# UNITED STATES PATENT AND TRADEMARK OFFICE

APPLICATION NO.	FILING DATE	FIRST NAMED INVENTOR	ATTORNEY DOCKET NO.	CONFIRMATION NO.
09/822,154	03/30/2001	Robert A. Immerman	IN0191US (#90067)	6306

**Office Action Summary**

## **DETAILED ACTION**

210,833

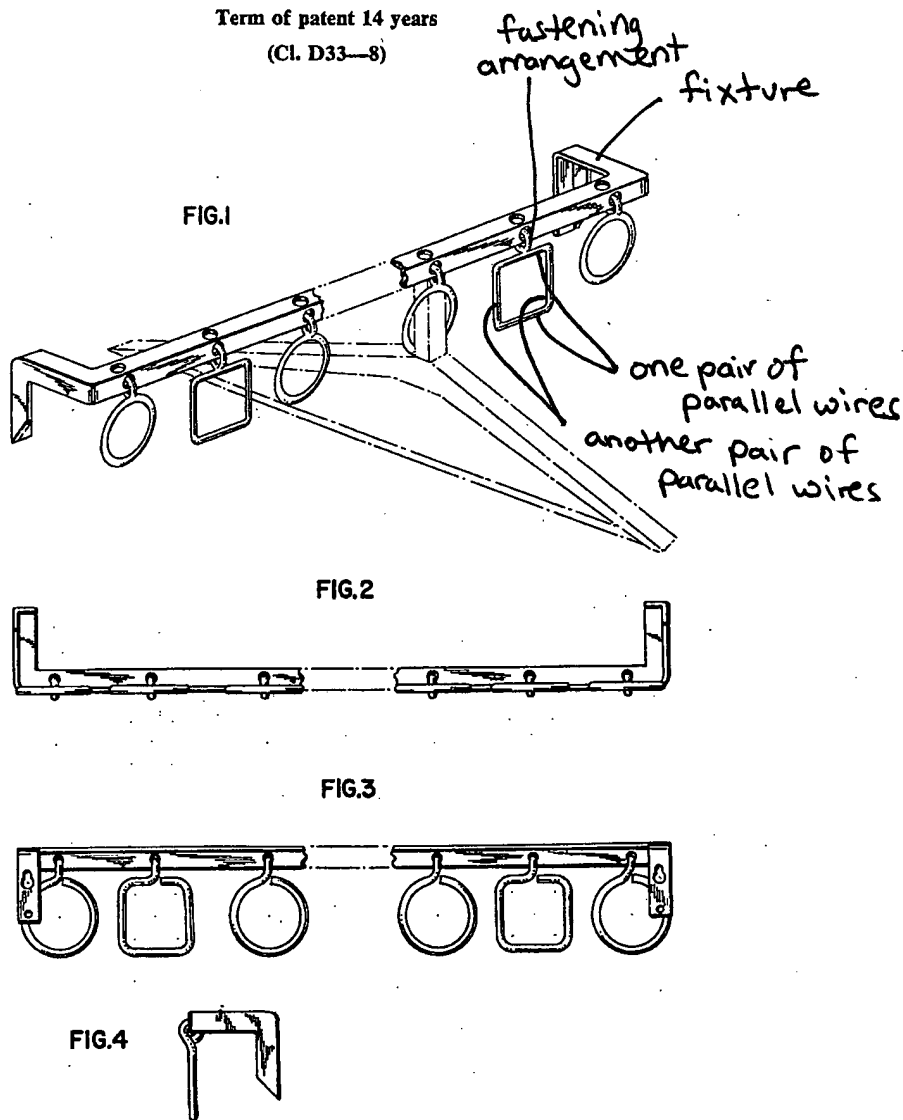
Claims 1, 7-9, 21 are rejected under 35 U.S.C. 102(b) as being anticipated by Cura (Des. 210,833). See attached drawing for more details. Cura shows a first pair of parallel wires, and a second pair of parallel wires traverse to and engaging the first pair of wires and defining a rectangular opening that is capable of receiving the head of a suction cup and retaining the neck, and a fastening arrangement for fastening the device to a fixture. One pair of wires is horizontal and the other pair is vertical.

Des. 121,813

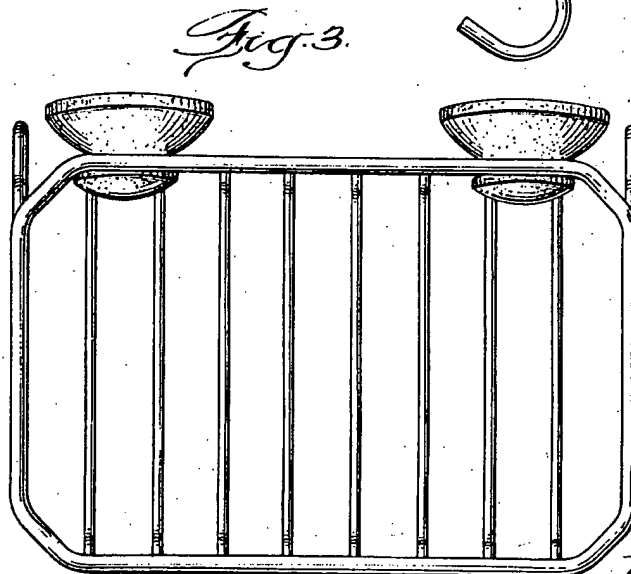
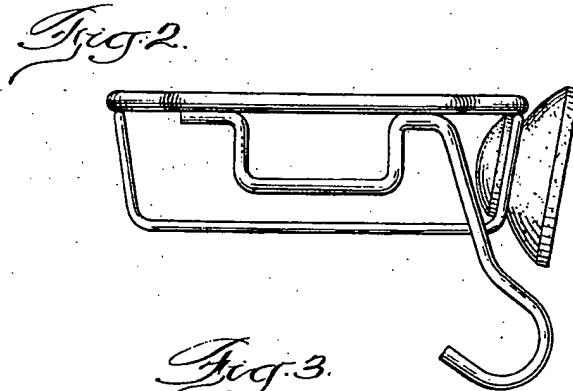
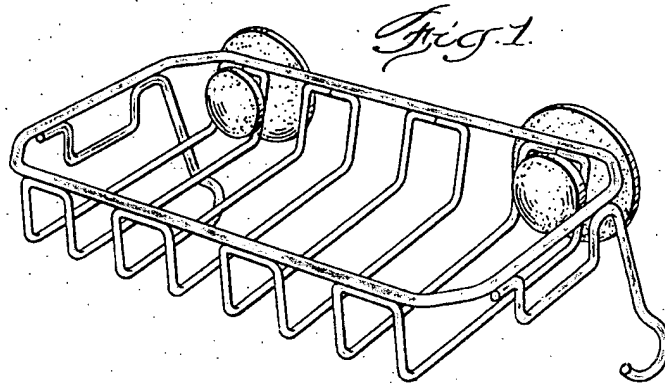
Claim 1, 6-8, 11, 16-18, 21 are rejected under 35 U.S.C. 102(b) as being clearly anticipated by Isenburg (Des. 121,813). See attached drawing for more details.

Isenburg shows a first pair of horizontal, generally parallel, rigid wires (in yellow), a second pair of non-parallel rigid wires (in orange) transverse to and engaging the first pair of rigid wires defining a generally rectangular opening for receiving the head of a suction cup and for retaining the neck in the opening, and a fastening arrangement that holds the second pair of wires attached to the fixture (in blue). The suction cup has a compressible head attached to a neck, the neck is attached to an engagement member, the head is insertable into the opening and the neck is retained in the opening.

Claims 2-5, and 12-15 are rejected under 35 U.S.C. 103(a) as being unpatentable over Isenberg (Des. 121,813) in view of Macek (5,620,105). Isenberg shows all the features claimed in the applicant's invention but does not specifically state
